STONEBRIDGE WOODS
SUBDIVISION OBSERVATION REPORT

July 25, 2012

HR GREEN JOB NO. 86120056

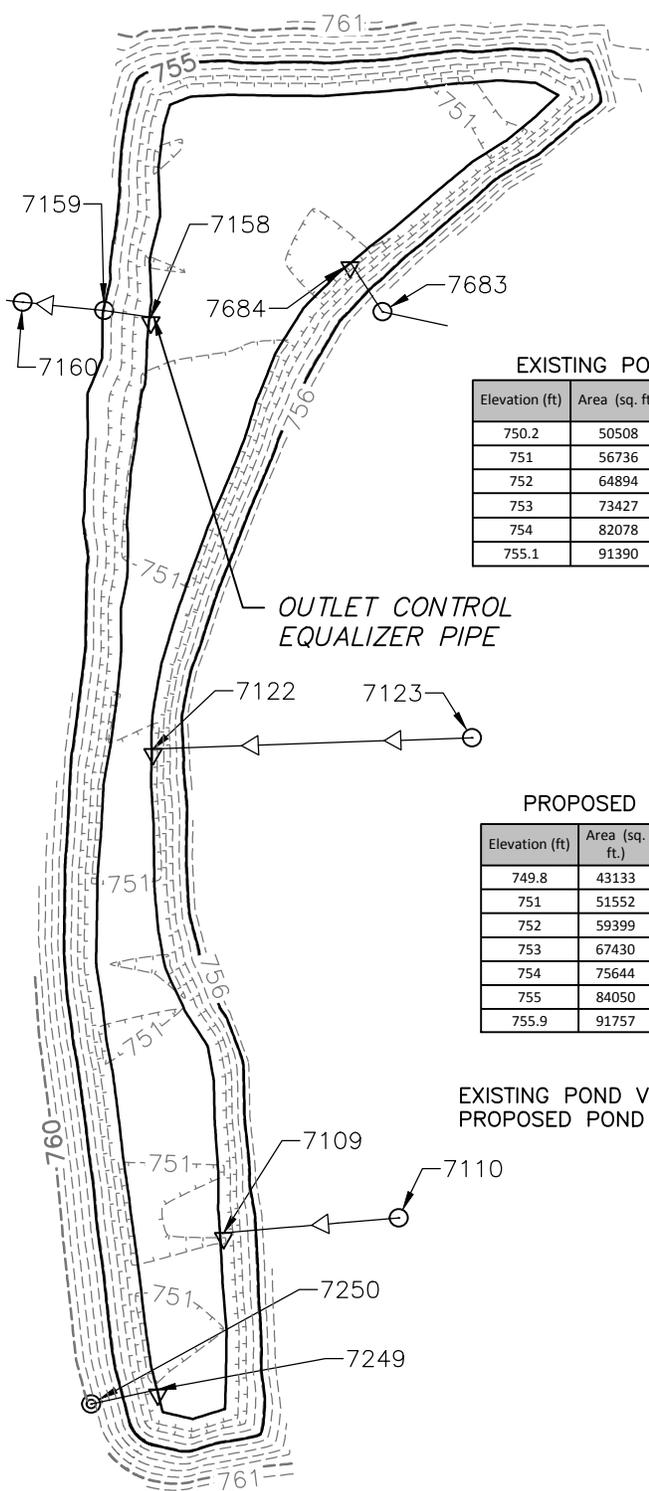
proposed design. The 100-year emergency overflow was constructed 2.83' lower than the proposed elevation. This results in a reduced storage volume for the basin. This basin does not comply with the design plans.

POND D

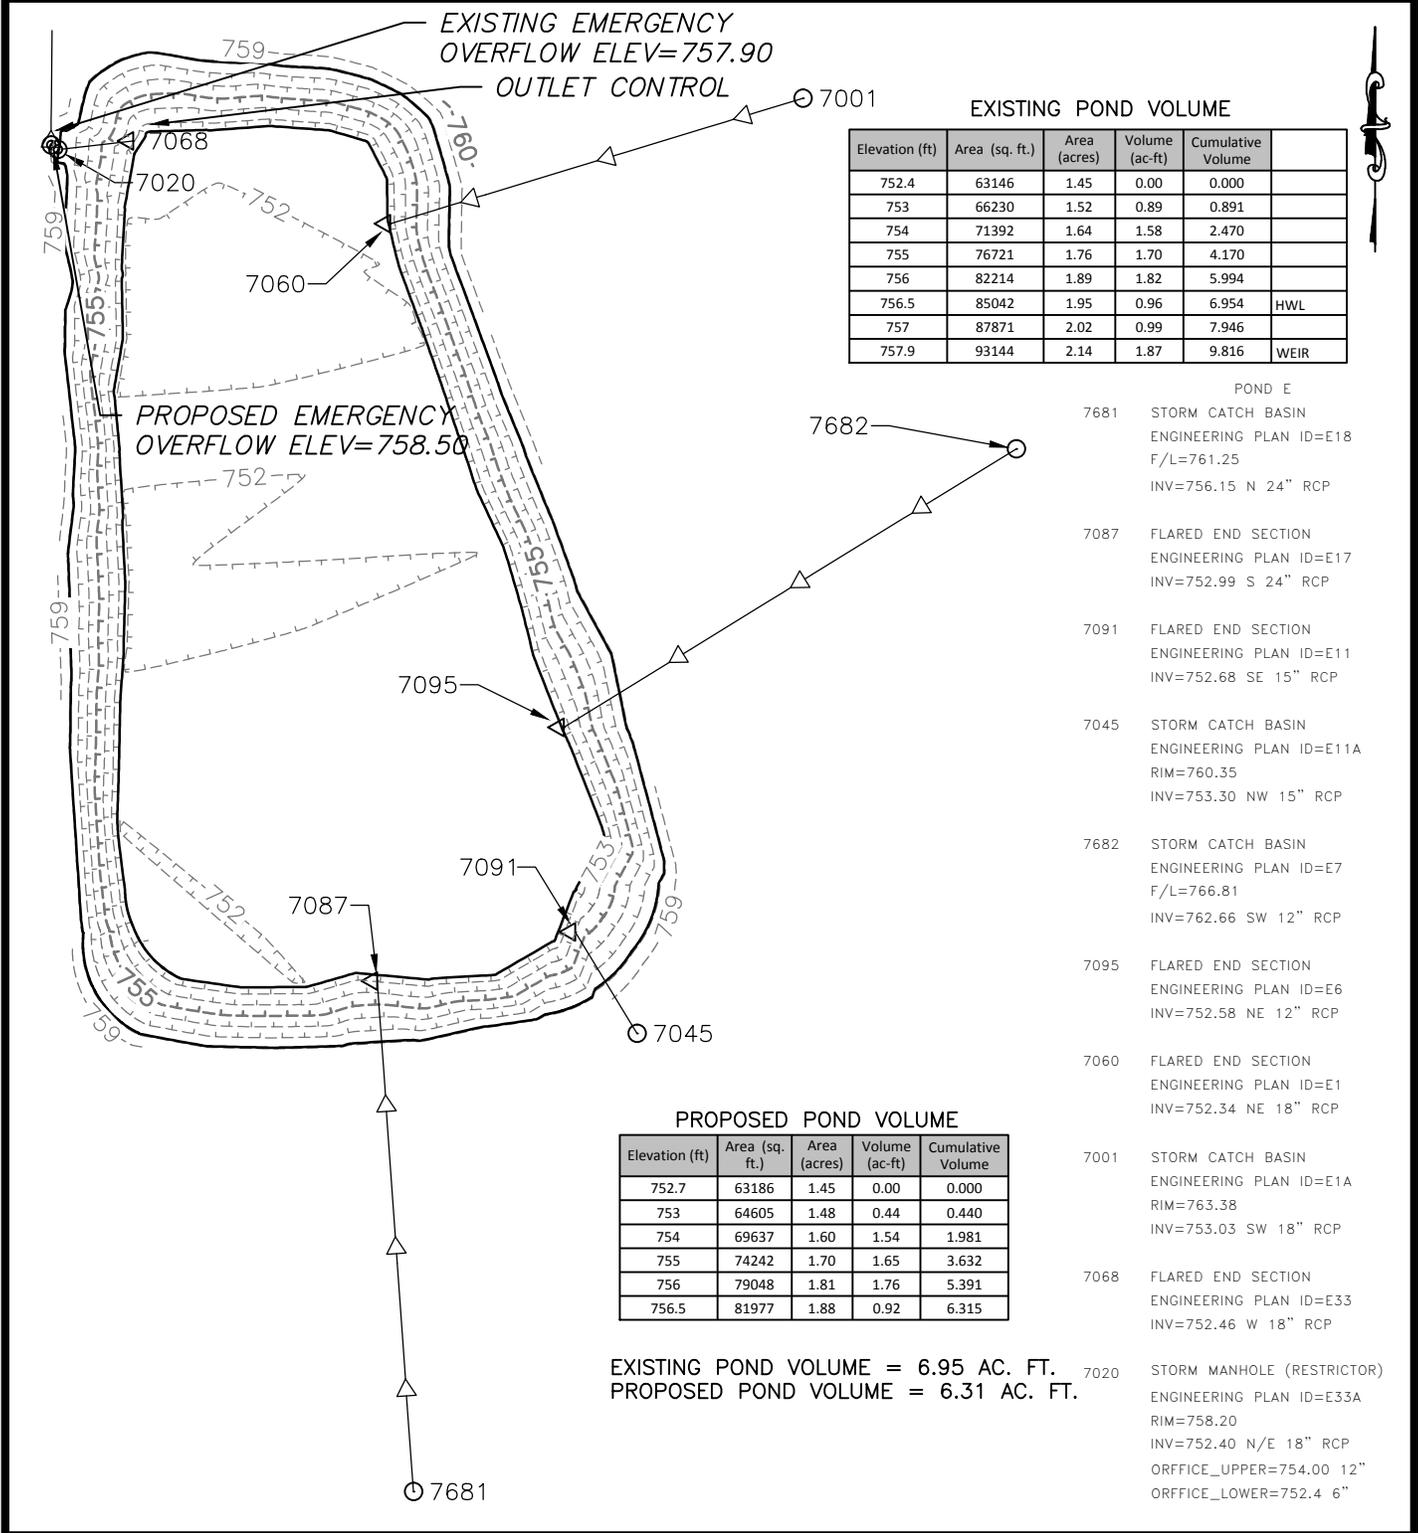
The outflow equalizer pipe was constructed 0.32' higher than proposed. This raises the NWL resulting in a reduced storage volume. The HWL for this pond is controlled by the downstream overflow of Pond C. The 100-year emergency overflow for Pond C was constructed 2.83' lower than the proposed elevation. This also reduces the storage capacity of the pond. This basin does not comply with the design plans.

POND E

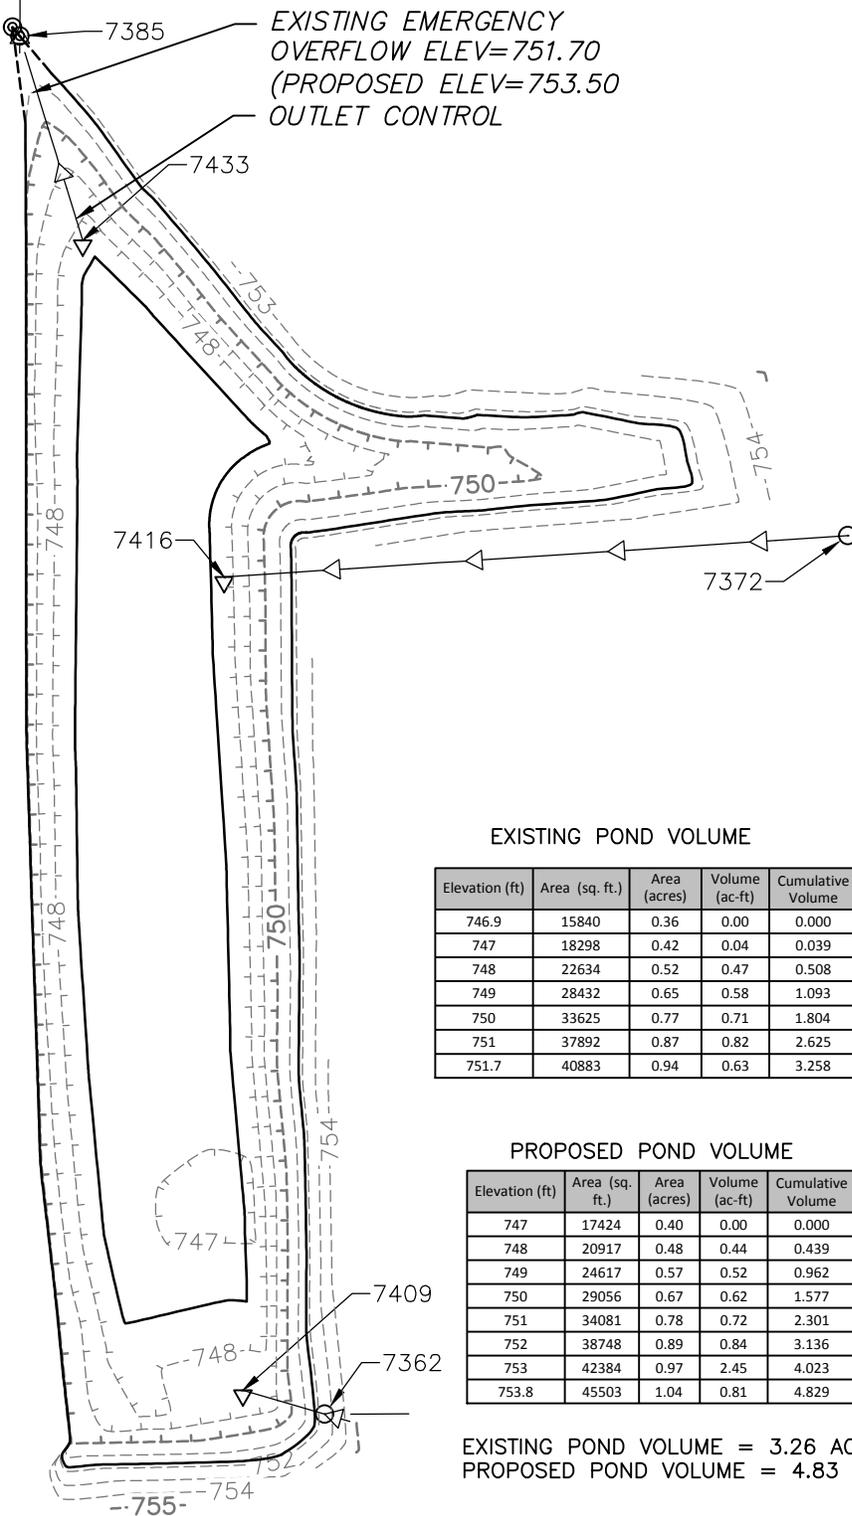
The 2-year and 100-year restrictors were constructed 0.56' lower than proposed. The 2-year restrictor was 2.35" too large and the 100-year restrictor was 0.20" too large. All of these deviations will result in release rates that do not comply with the proposed design. The 100-year emergency overflow was constructed 1.80' lower than the proposed elevation. This results in a reduced storage volume for the basin. This basin does not comply with the design plans.

STONEBRIDGE WOODS
 POND F

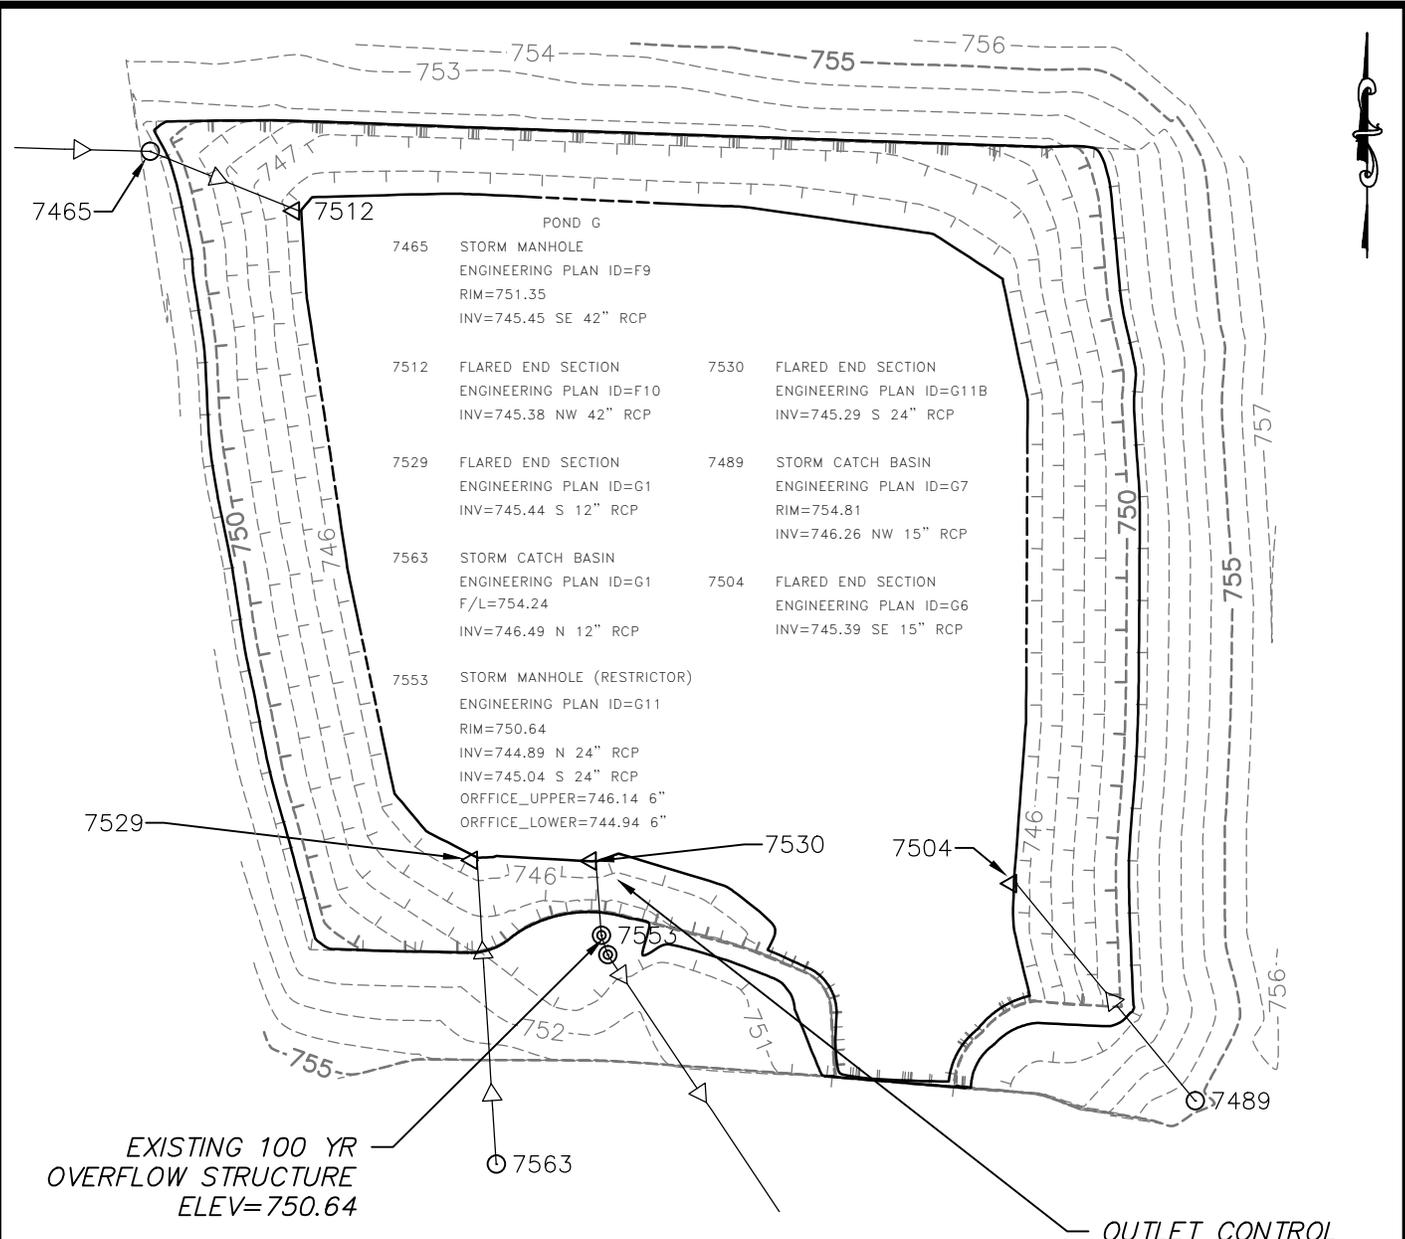
The restrictor pipes were all constructed an average of 0.7' lower than proposed. The 2-year restrictor was 0.50" too large and the 100-year restrictor was 0.10" too large. All of these deviations will result in release rates that do not comply with the proposed design. The 100-year emergency overflow inlet structure was constructed 0.96' lower than the proposed elevation. This results in a reduced storage volume for the basin. This basin does not comply with the design plans.

STONEBRIDGE WOODS
 POND G

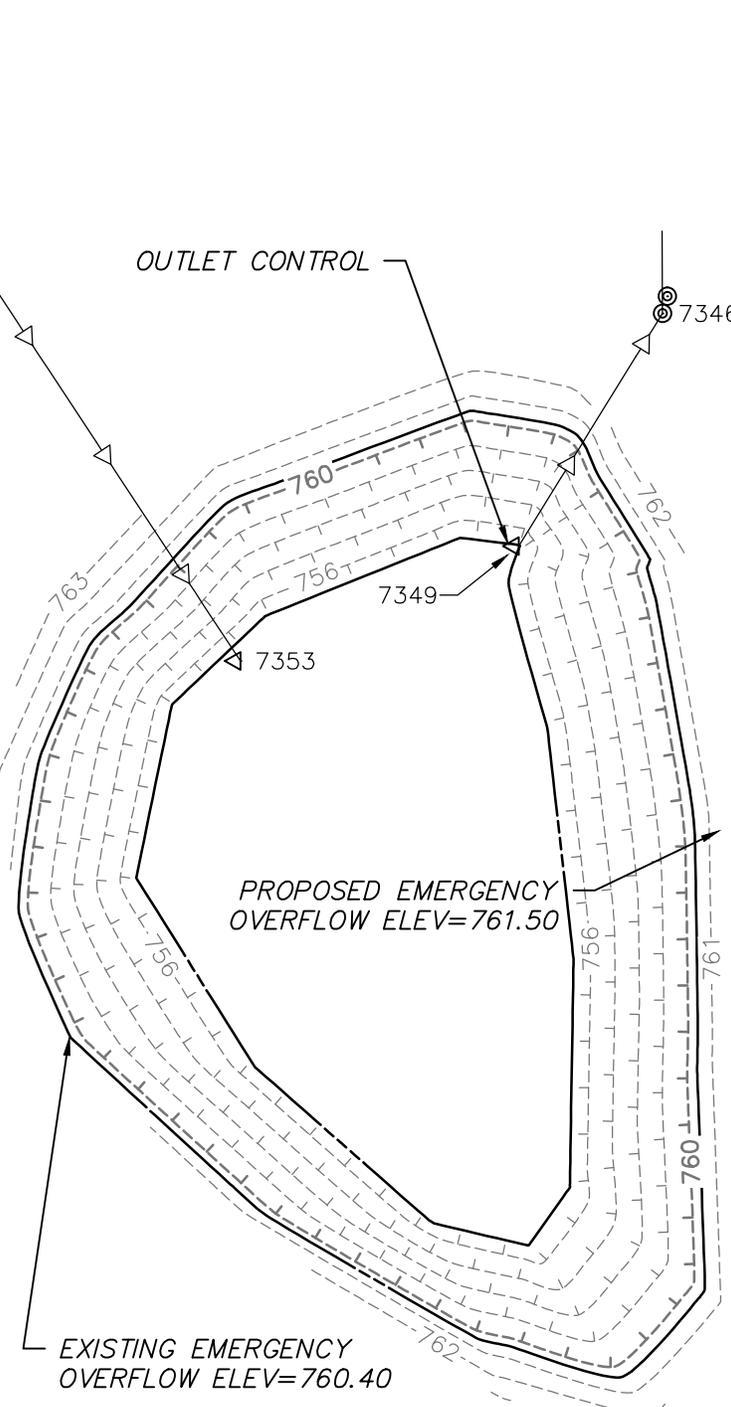
The diameter of the 2-year restrictor orifice was constructed 0.75" larger than was proposed. The 100-year restrictor orifice was not proposed on the plans but a 6" restrictor was constructed. These deviations will result in release rates that do not comply with the proposed design. The 2-year restrictor was constructed 0.40' lower than proposed which results in an increase of storage volume. The 100-year emergency overflow for Pond H was constructed 1.10' lower than the proposed elevation and in the incorrect location. This reduces the storage capacity of the pond but since the pond was designed with 2.4' feet of

freeboard above the calculated HWL there is an additional 0.62 ac.ft of potential storage capacity in the pond. This basin does exceed the proposed storage volume but it does not comply with the design plans.

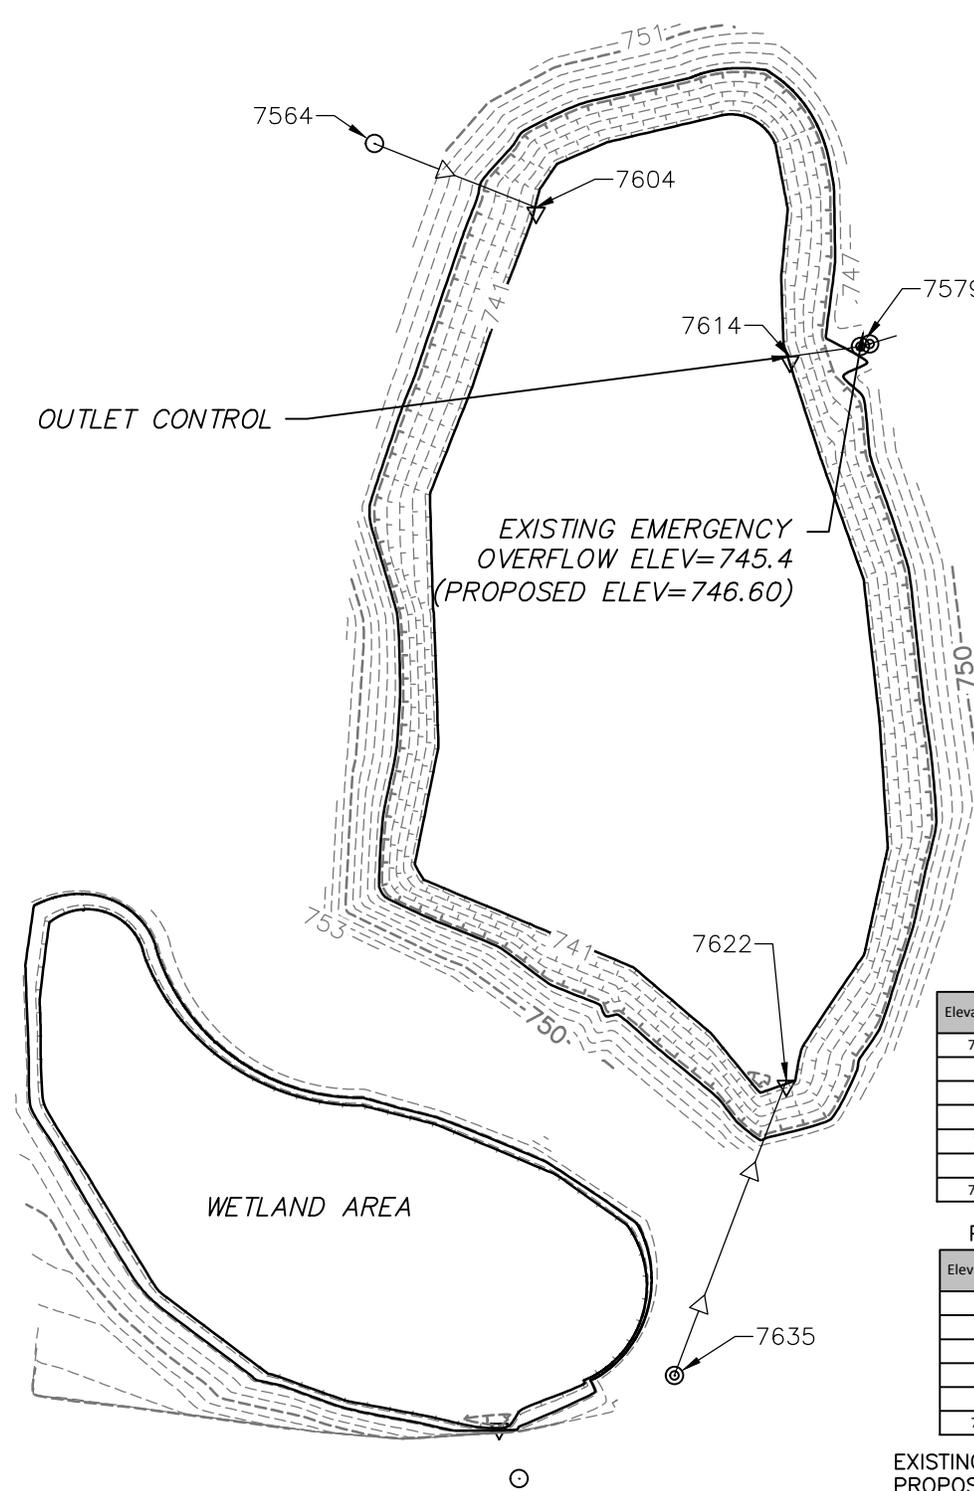
The restrictor pipes were all constructed an average of 0.47' lower than proposed. The diameter of the 2-year restrictor orifice was constructed 2.09" larger than was proposed. The diameter of the 100-year restrictor orifice was constructed 1.23" larger than was proposed. These deviations will result in release rates that do not comply with the proposed design. The 2-year restrictor was constructed 0.40' lower than proposed which results in an increase of storage volume. The 100-year emergency overflow for Pond J was constructed 1.20' lower than the proposed elevation. This reduces the storage capacity of the pond. This basin does not comply with the design plans.
